CCO #SC01-001

Project: AS7.001.001 - Ogdensburg CSD CIP Phase 1
 1100 State Street
 Ogdensburg, New York 13669

**Change Order Authorization #SC01-001:
 CE #040 - Transportation Entrance Gate Changes**

BUILDING	SHEET NUMBER
JC-14	2
	AD3/C-601

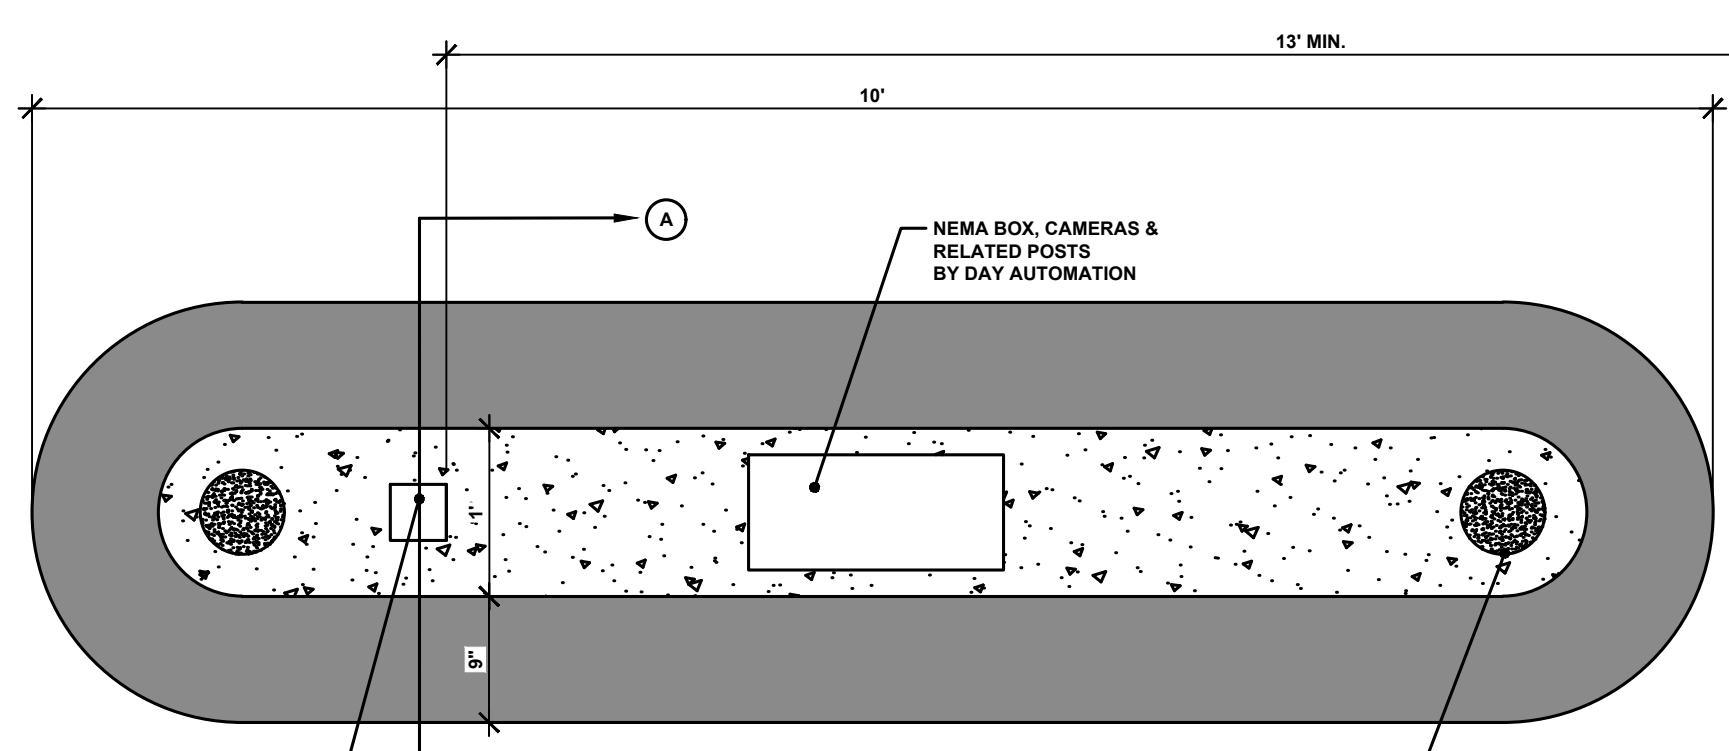
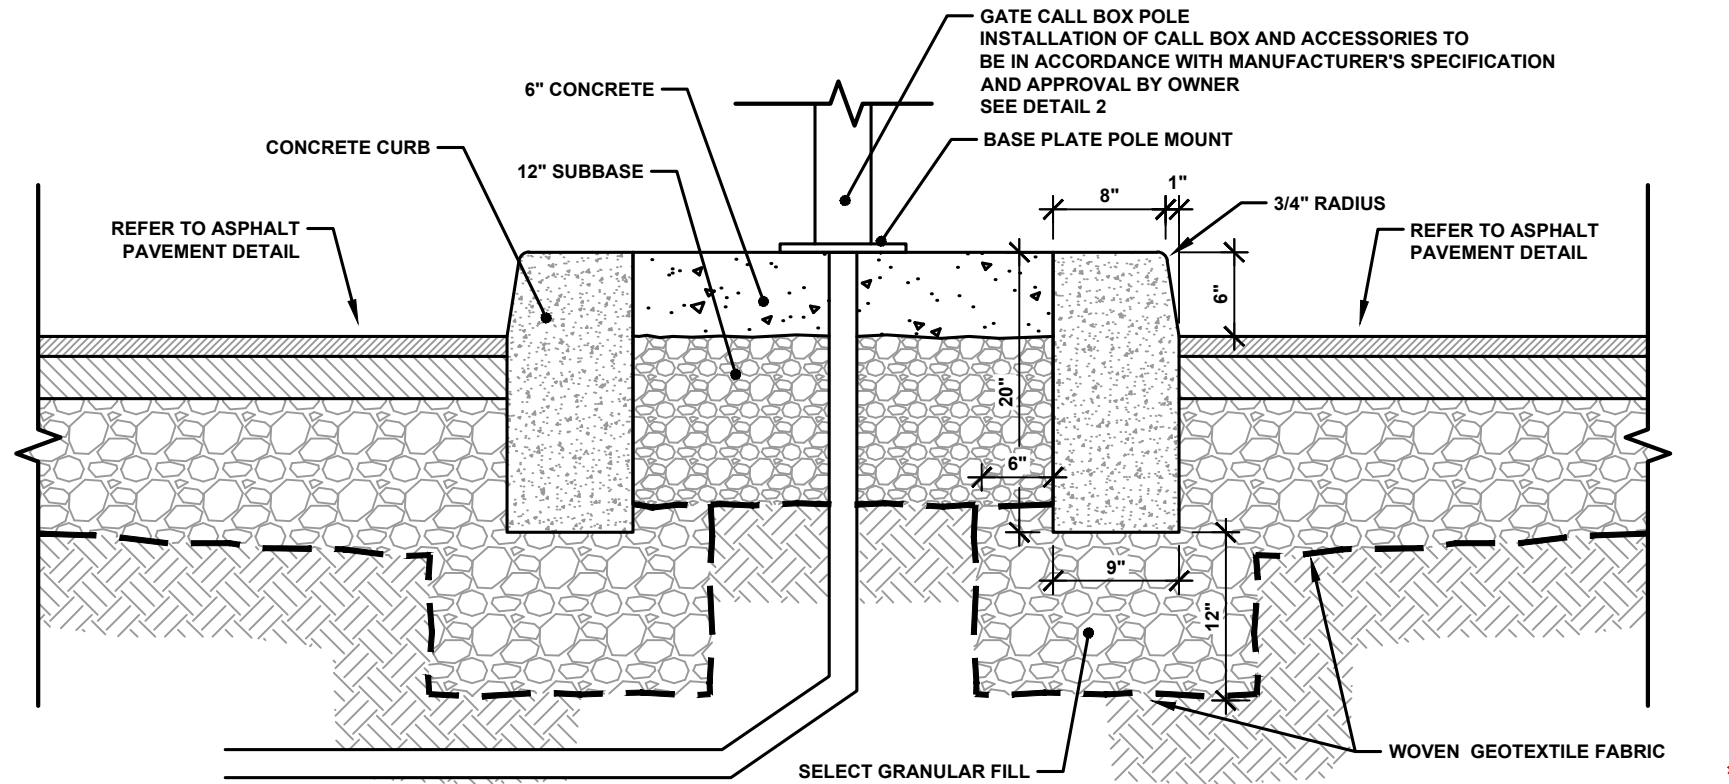
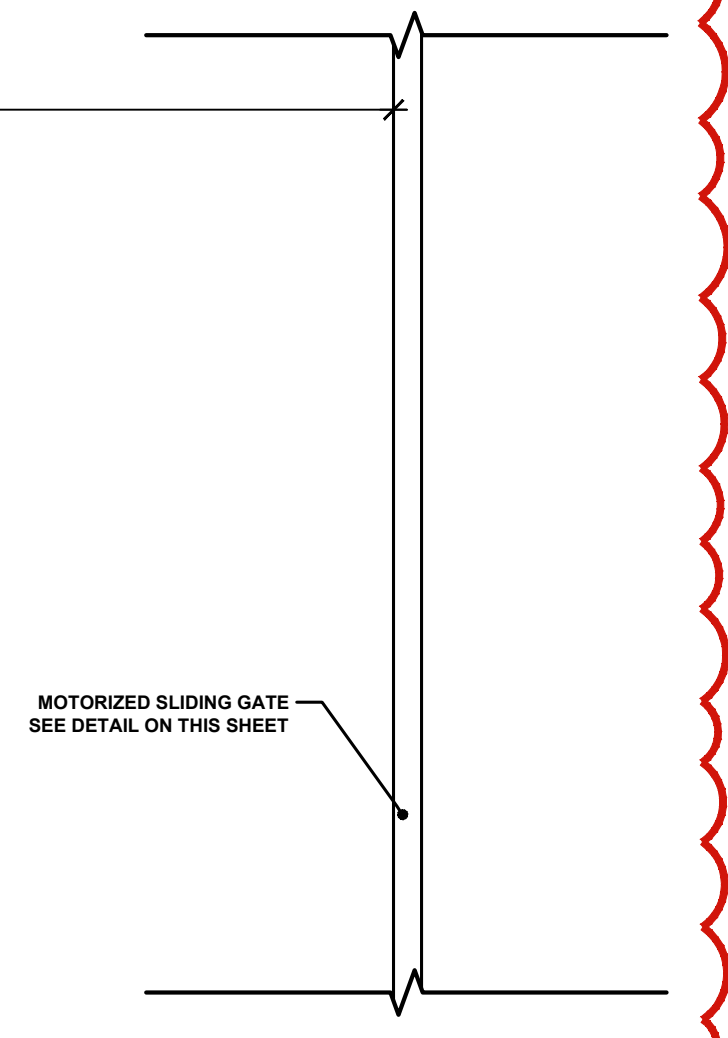
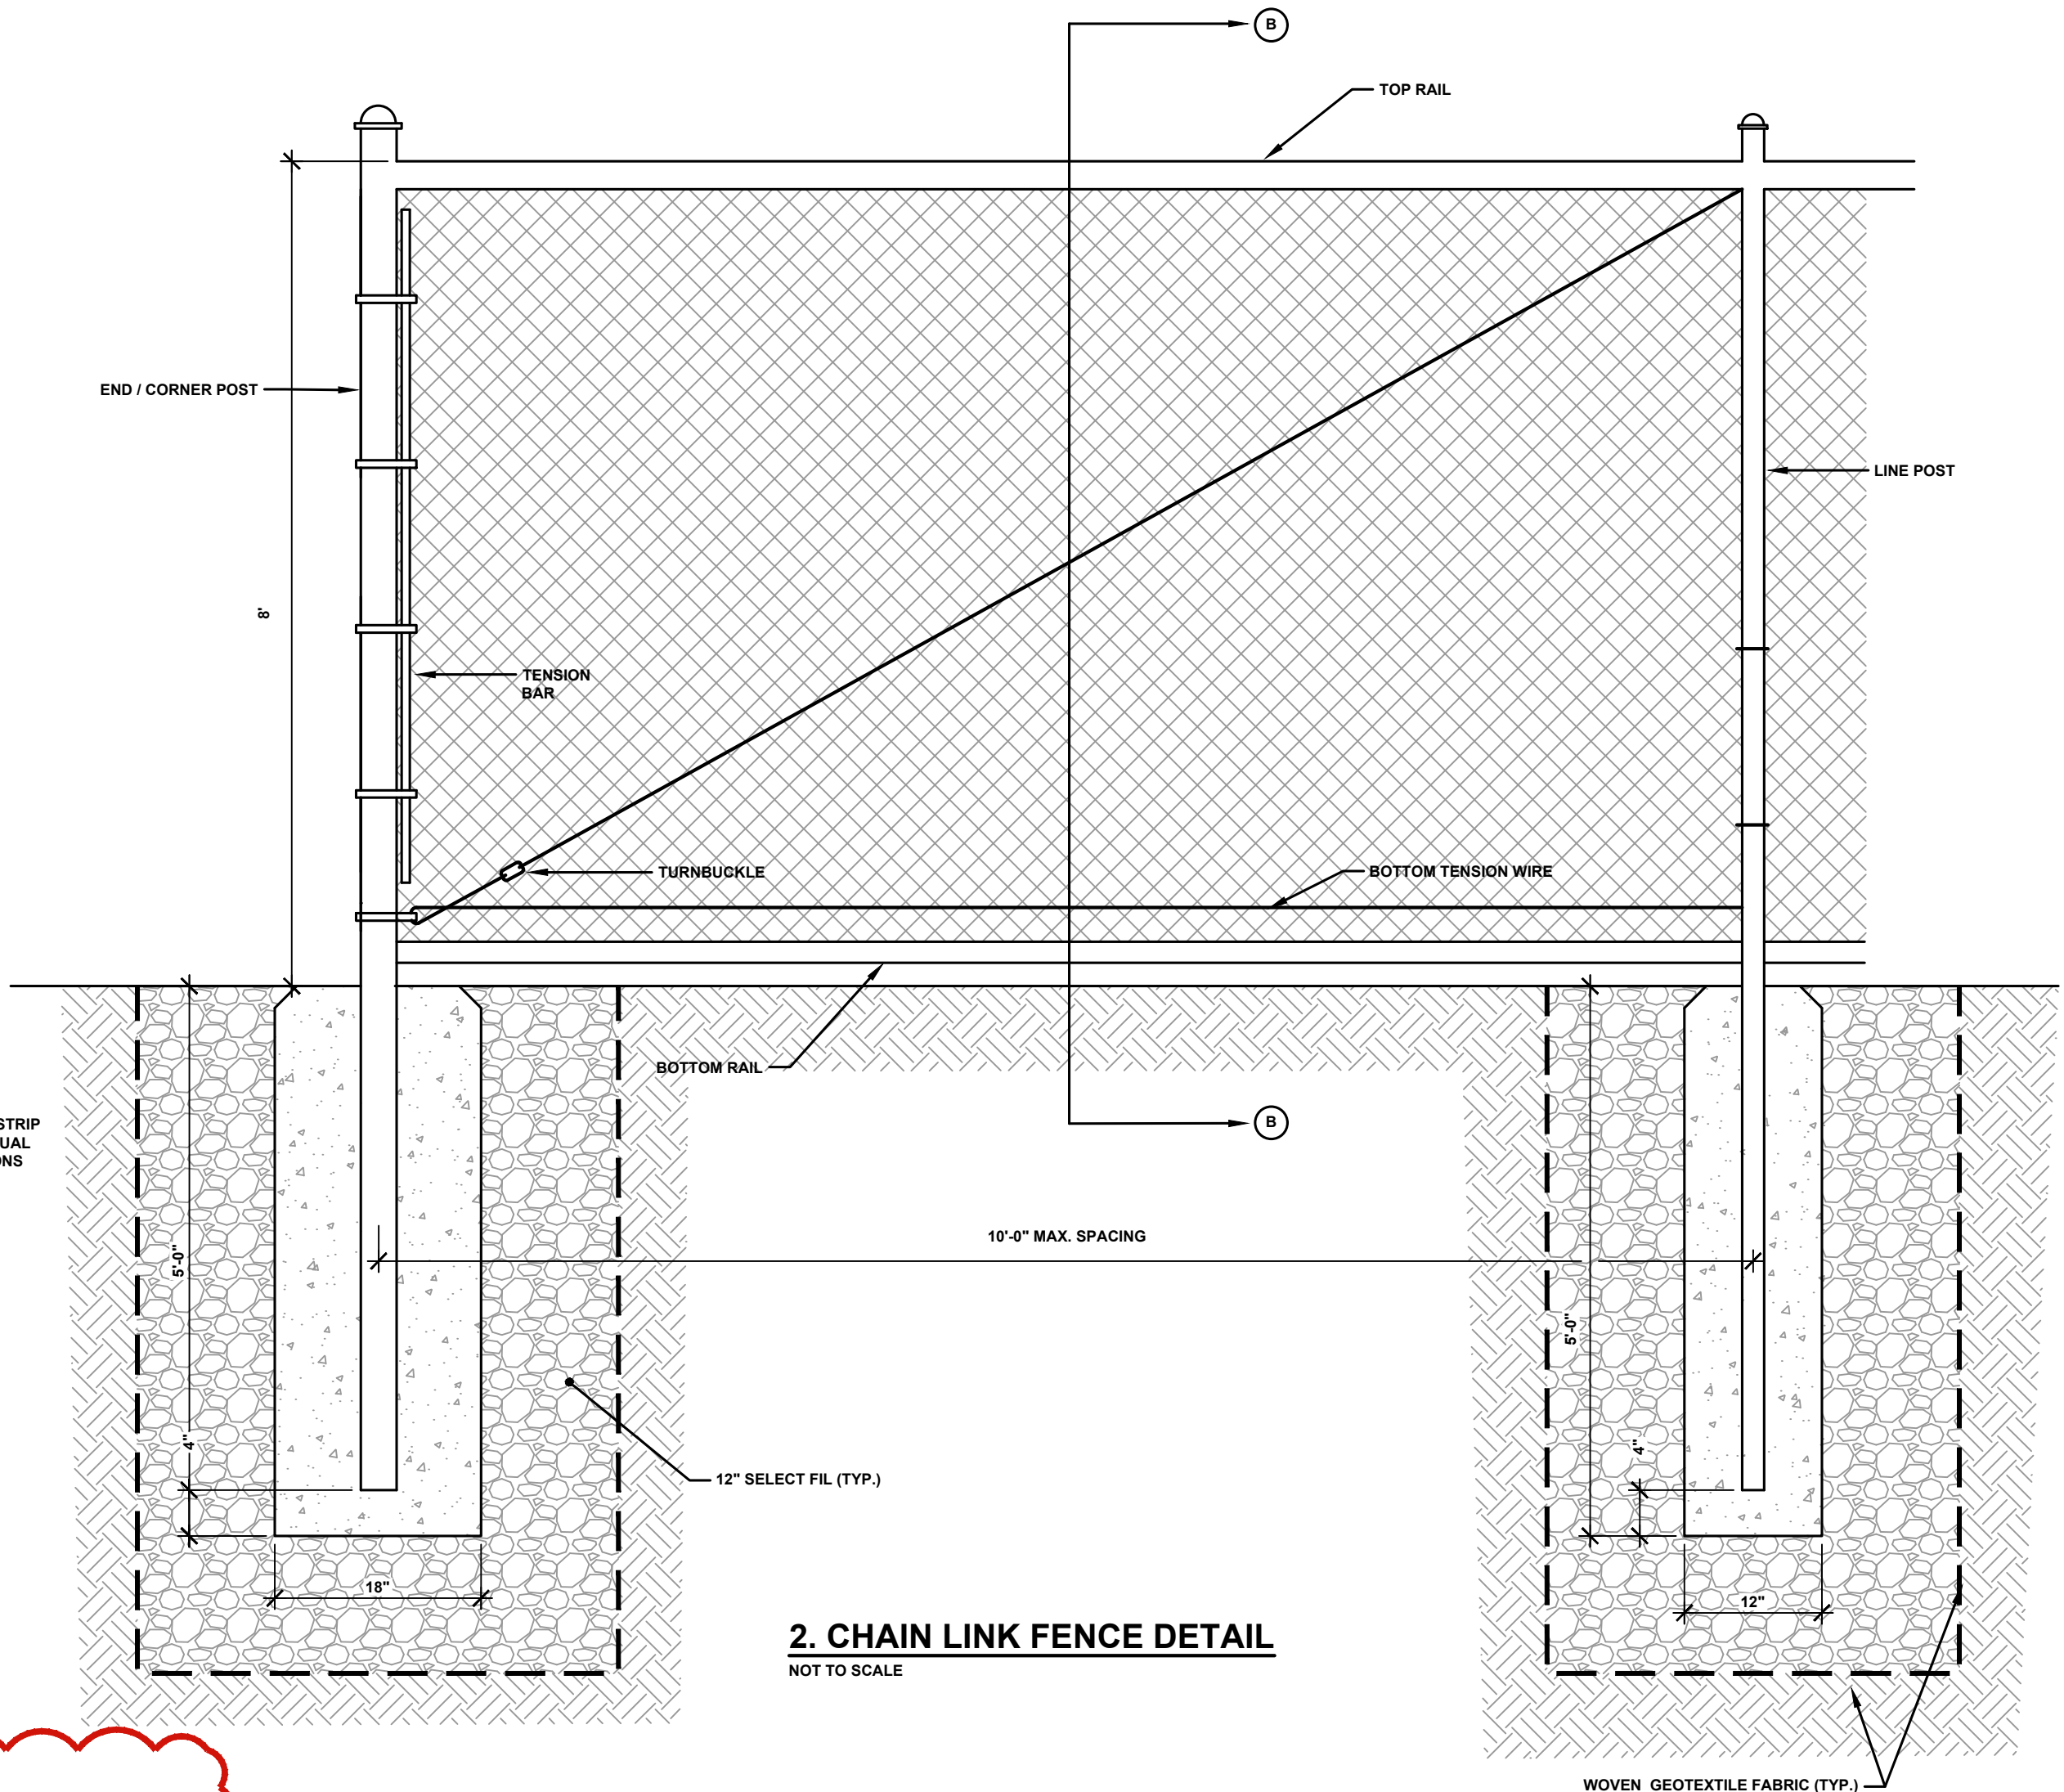
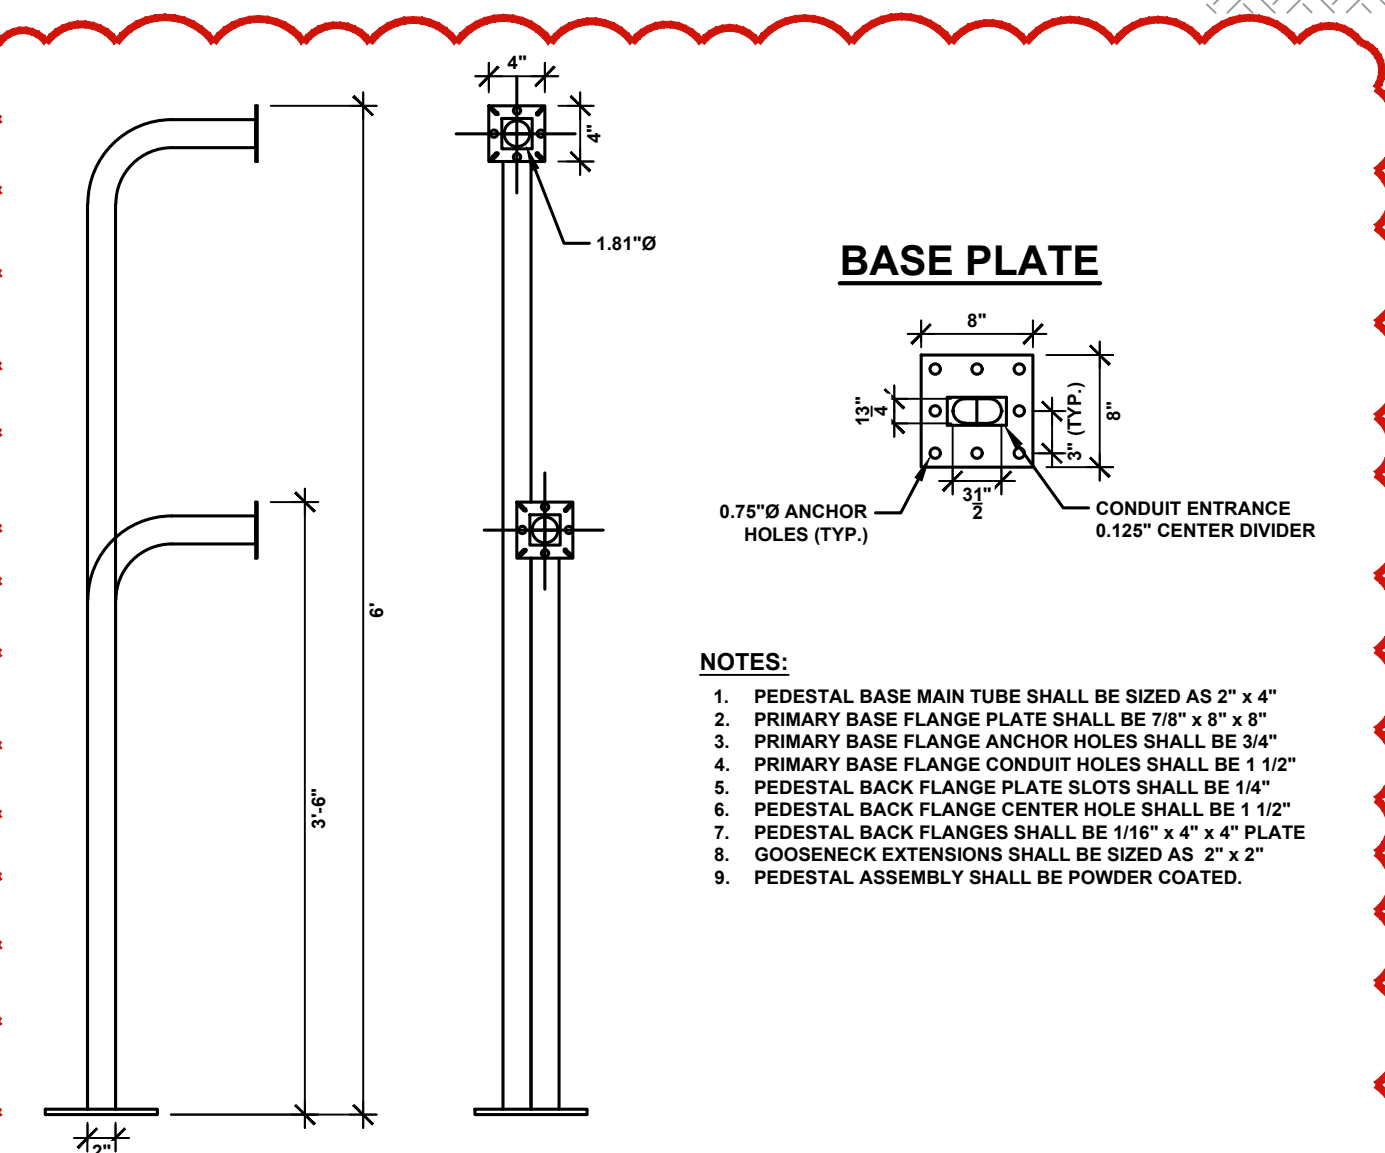
At the District's request, enhanced communication and security capabilities are being added at the entrance gate to the new Transportation Facility, per attached JC-14 drawings.	\$41,578.36
---	-------------

D.	Add for all labor, materials & equipment to provide enhanced security access control features to include exterior dual head camera & related pedestal, (2) Axis video intercoms w/ integrated card readers, fiber optic panel and access control panel for the drive entrance at the new Transportation Facility as per Contract Drawing(s) JC-14.
